PLANNING COMMISSION AGENDA

Tuesday, May 06, 2014
Breckenridge Council Chambers
150 Ski Hill Road

Planning Commission Staff Report

Epic on French
308 N. French Street
Breckenridge, CO 80424

LANDSCAPE PLAN

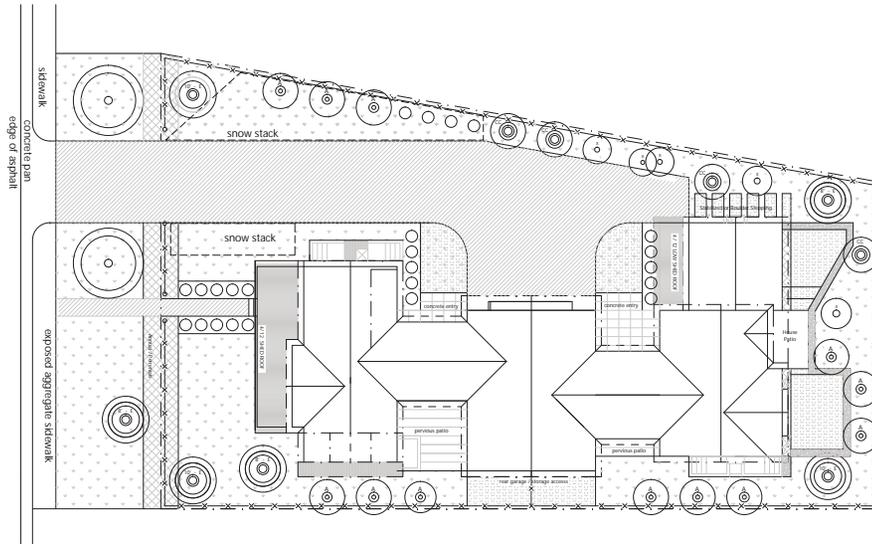
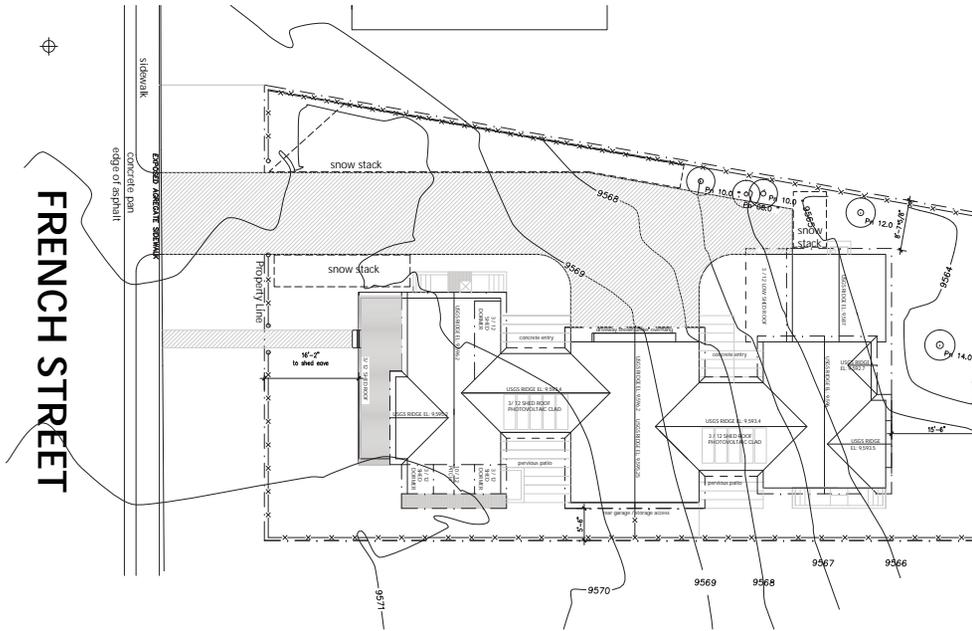
- *Planting new cottonwood trees to define the street edge is encouraged.* Applicant has proposed two narrow leaf cottonwood or Balm of Gilead along N. French Street. The cottonwood trees are proposed off the property, but along the street edge as the Historic District Guidelines encourage. The placement of these trees in the public right of way will require an encroachment license agreement and is supported by staff to further define the street edge with trees found historically in the area.

153. Respect existing stands of mature trees. The drawings show the protection of a nice stand of existing evergreen trees along the northern property line and a specimen evergreen tree will be retained along the eastern property line.

- *Use large trees to reduce the perceived scale where larger building masses would abruptly contrast the historic scale of the area.* As discussed above, the increased size of the proposed evergreen trees will accomplish this design standard. Also, some large existing evergreen trees will be retained along the northern property line and the eastern property line.
- *Include hedges and other masses of lower-scale plantings to screen service areas.* The landscaping plan has shrubs and hedges proposed to screen service areas.

After the revisions the applicant made to address Staff concerns and meet the Historic District Guidelines, Staff supports positive two (+2) points under Policy 22 (Relative) Landscaping. The landscaping plan includes small 1'-2' tall retaining walls to allow for a flat patio and retention of a specimen evergreen tree along the eastern portion of the lot.

PROPOSED
 SITE PLAN

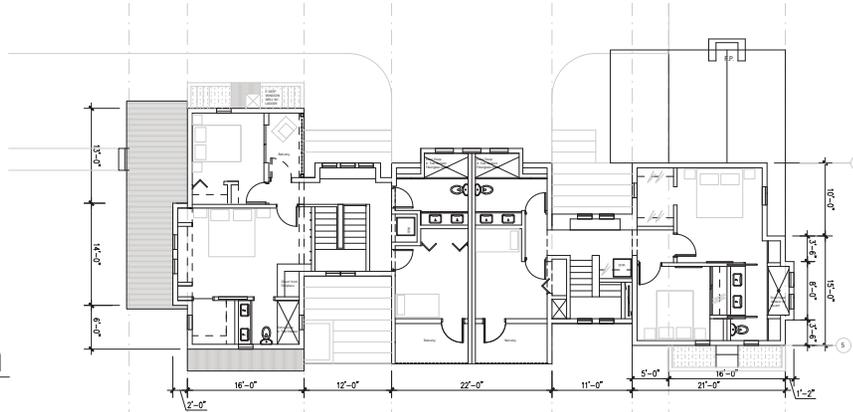
Building Height (6/A & 6/R): At the previous Planning Commission work session, Staff was concerned with the height of the proposed duplex. The Development Code strongly encourages maximum height of 23' to the mean. The drawings show that 25' is the maximum height proposed to the mean. Per the North End Character Area section “Building Height”:

compatible with the context. (Emphasis added.) Per the Development Code Policy 6/R, Height: *A maximum height of 23' is strongly encouraged.* Applicant has designed the proposed structure at the maximum of 25' to the mean. Land Use District 18 allows heights as tall at 26' to the mean with negative points.
